ADDENDUM NO. 5

BARNSTABLE
**Federal Aid Project Nos. CMQ-0035(043), HSI-0035(043), NFP(N/I)-0035(043),
STP-0035(043) & TAP-0035(043)**
Intersection Improvements and Related Work (Including Signals)
at Iyannough (Route 28) and Yarmouth Roads

Transmitting changes to the Contract Documents as follows:

TRAFFIC SIGNAL PLANS

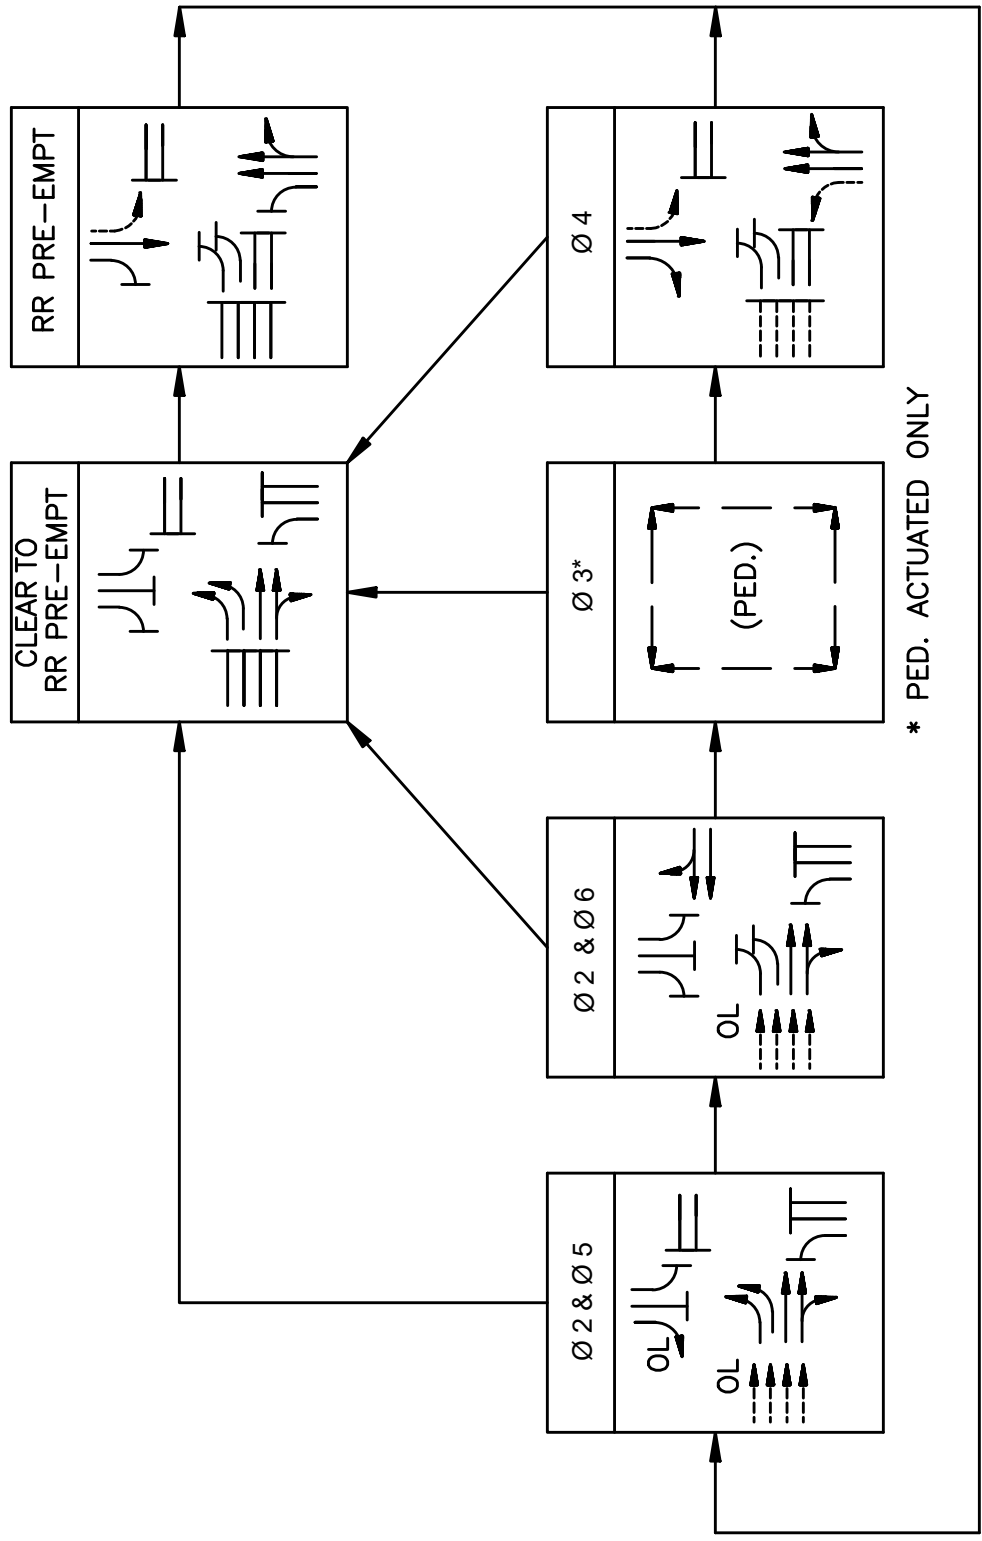
Revised sheets 89 and 90 of 231.
